## **LAKESIDE COMMERCIAL PARK SUBDIVISION, TENTH ADDITION, RESUBDIVISION OF LOTS 2 & 3**

APPLICATION NUMBER 6 DATE June 2, 2005

REQUEST Subdivision

# LAKESIDE COMMERCIAL PARK SUBDIVISION, 10TH ADDITION, RESUBDIVISION OF LOTS 2 & 3

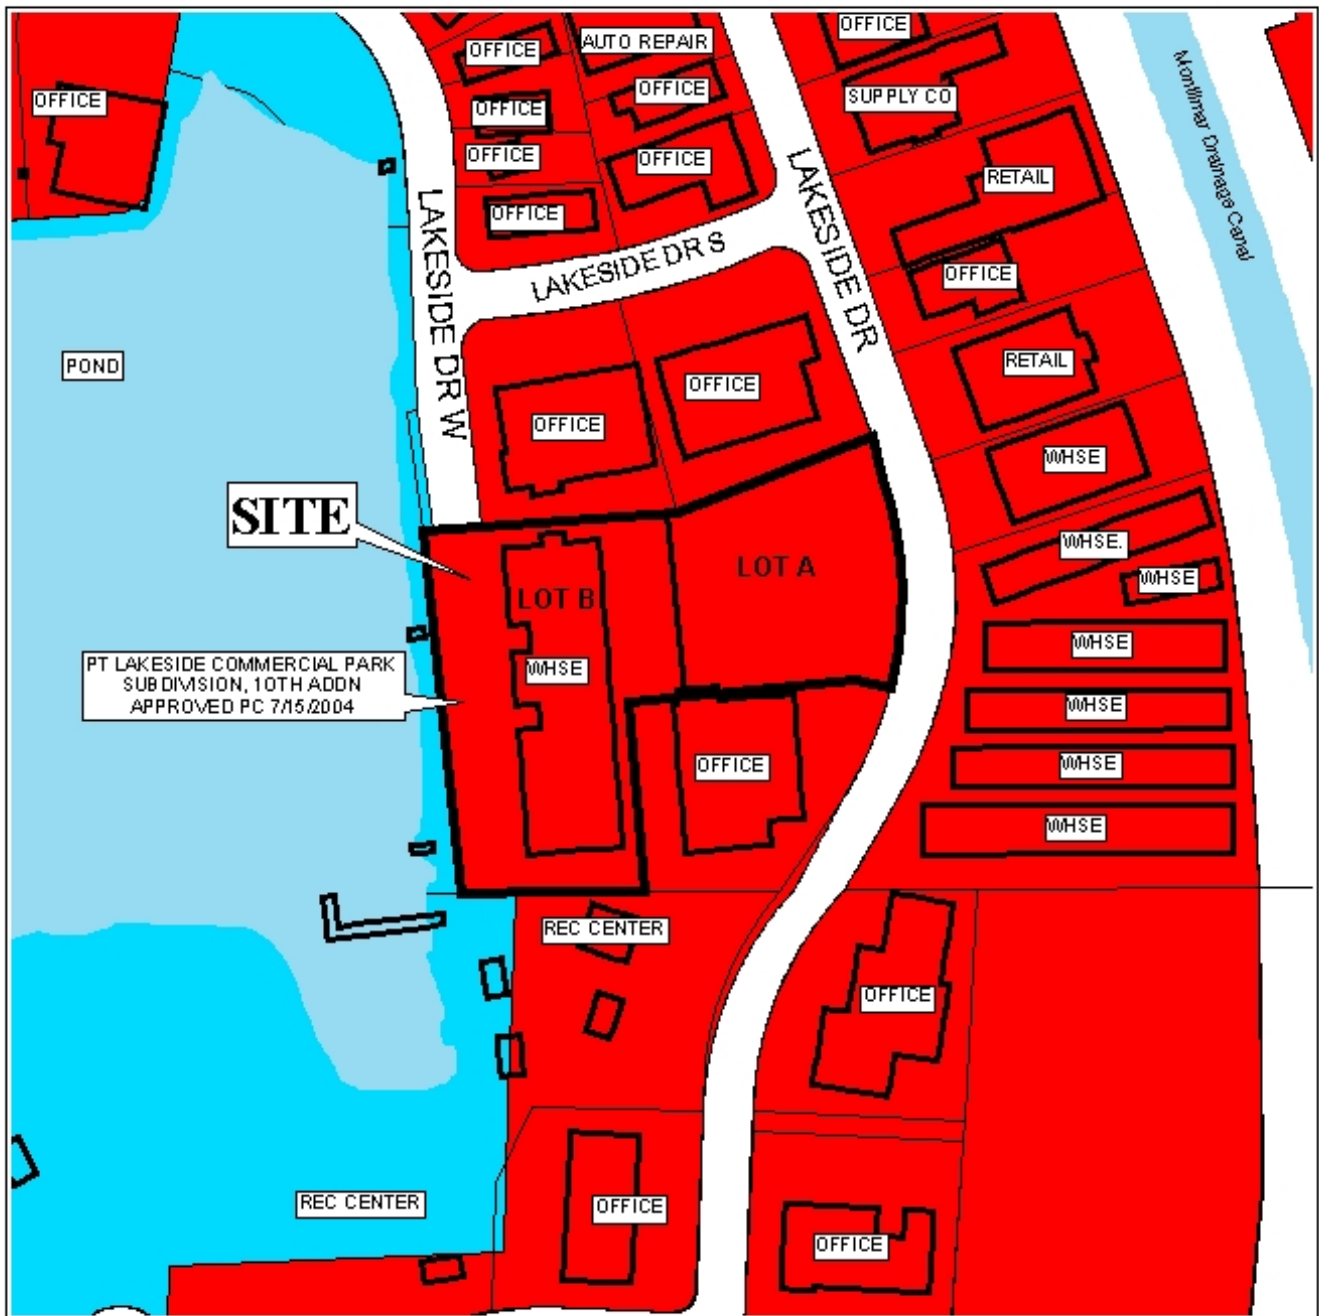
The 25-foot minimum building setback line from the right-of-way edge is not shown for the proposed "Lot B," adjacent to the Lakeside Drive West stub, but would be required on the Final Plat, if approved.

The plat is recommended for Tentative Approval subject to the following conditions: 1) the depiction of the 25-foot minimum building setback line on the Final Plat; and 2) conformance with all applicable regulations.
